Official Transcript of Proceedings
NUCLEAR REGULATORY COMMISSION

Title: Advisory Committee on Reactor Safeguards

Date: Tuesday, July 9, 2013

ADVISORY COMMITTEE ON REACTOR SAFEGUARDS

Comparison to the motions recorded at the foundation slabs of Fukushima Daiichi Units 1 and 4

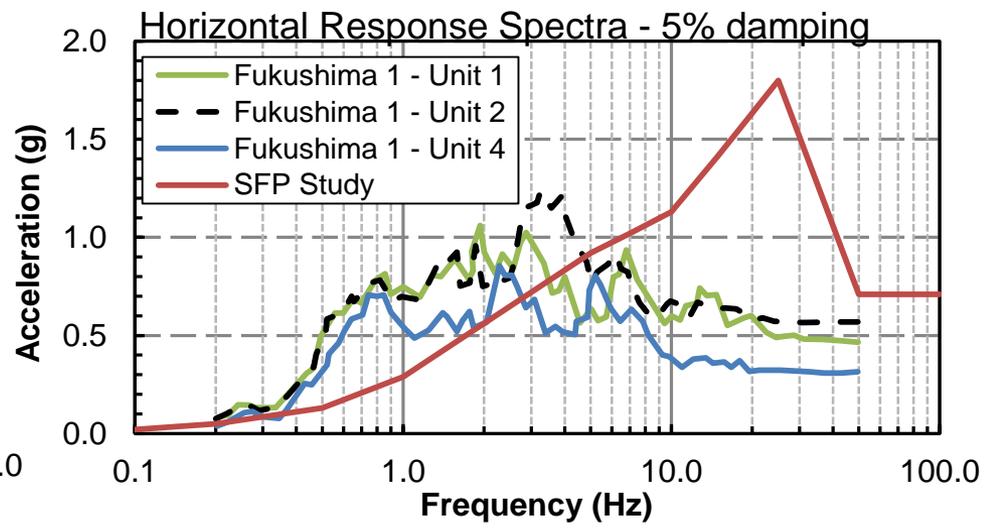
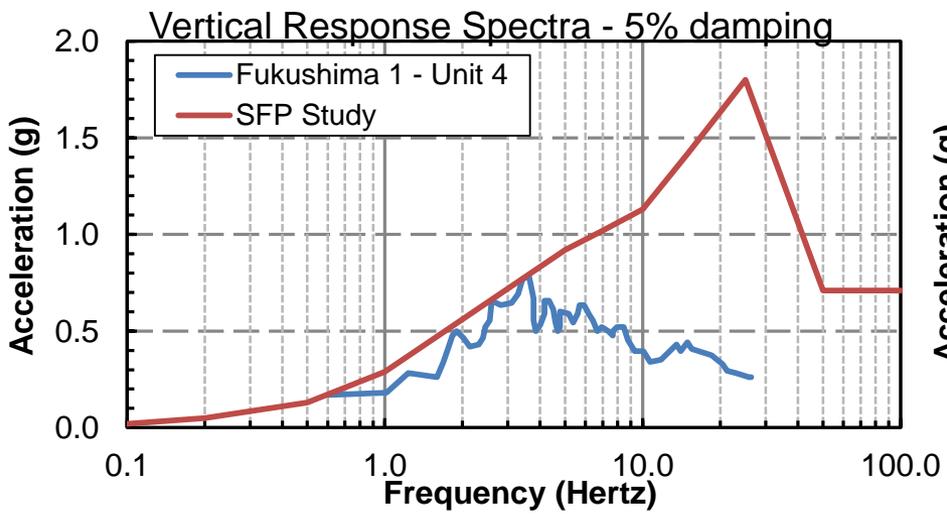
15 CHAIR ARMIJO: Jose, just to make sure to
16 clarify for me at least. This is not my area. I look
17 at these charts, particularly the horizontal response
18 factor. And it looks to me that the accelerations at
19 the Fukushima plants at least in the frequency range
20 of let's say 0.5 to 5.0 or something like that were
21 greater than the study boundary.

20 MEMBER STETKAR: Jose, this is -- I'm well
21 out of my area of knowledge here. I see the response
22 spectra that you selected for this study with a strong
23 peak around -- pick a number -- 20 to 30 Hertz. And
24 I see the response spectra that you've plotted for
25 Fukushima.

1 And I've also looked at several plant
2 specific response spectra that sort of have the shape
3 of the Fukushima. In other words, peaks around the
4 two to three to five to six Hertz range. What would
5 be just off the top the difference in the overall
6 results from your study if your redline showed more of
7 that shape? In other words, a much higher
8 acceleration at lower frequencies. I think that's a
9 little bit of what Sam was asking about.

9 MR. PIRES: Some structures like the
10 reactor building on the plant that we studied would
11 have a frequency around seven Hertz, the common
12 frequency. In other plants, it might even be lower.
13 But the spent fuel pool structure is different. So it
14 was be resonant more with the frequencies around ten
15 Hertz and about.

15 MR. PIRES: I think we also analyzed
16 another site. It was the Kashiwazaki plant site. In
17 that site, we also had response factor at some higher
18 elevations. In some of those cases the response
19 factor at Kashiwazaki at some higher elevation was
20 close to the one that we estimated for this site.
21 Closer.

Vertical displacement contours (maximum at the center of the floor ~ 15 mm)

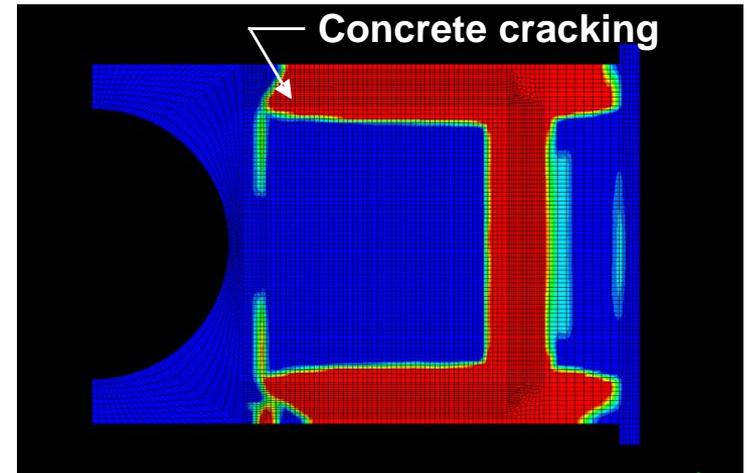
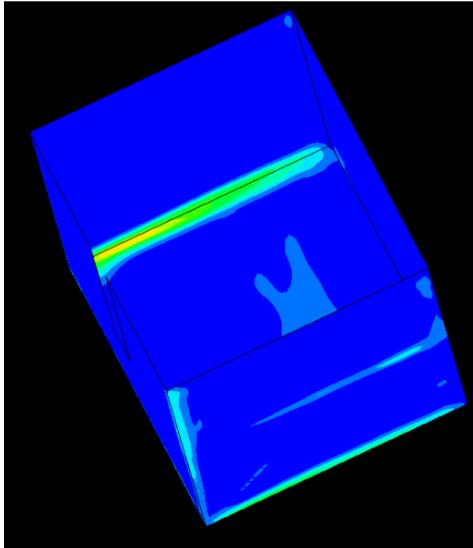
24 MEMBER CORRADINI: So let me ask a
25 different question because I know we've asked this

17 And what you see there was that you can
18 see on the figure on the top those contours there
19 which are the vertical displacements of the slab. And
20 you can see that there is a discontinuance.

5 So this continuity they provide stresses
6 on the concrete that's extended all across the
7 thickness of the wall right at the bottom of the wall.
8 And what I show in the bottom is essentially the
9 footprint of that crack. So it goes at the bottom of
10 the side walls, the wall near the outside. But in the
11 shield building you don't have that crack all the way
12 through because the shield building goes all the way
13 bottom to the foundation.

19 MR. PIRES: Yes, the red at the bottom
20 figure. That's the footprint of the crack which is
21 essentially the footprint of the walls. You're
22 looking from the top and that's the footprint of the
23 walls.
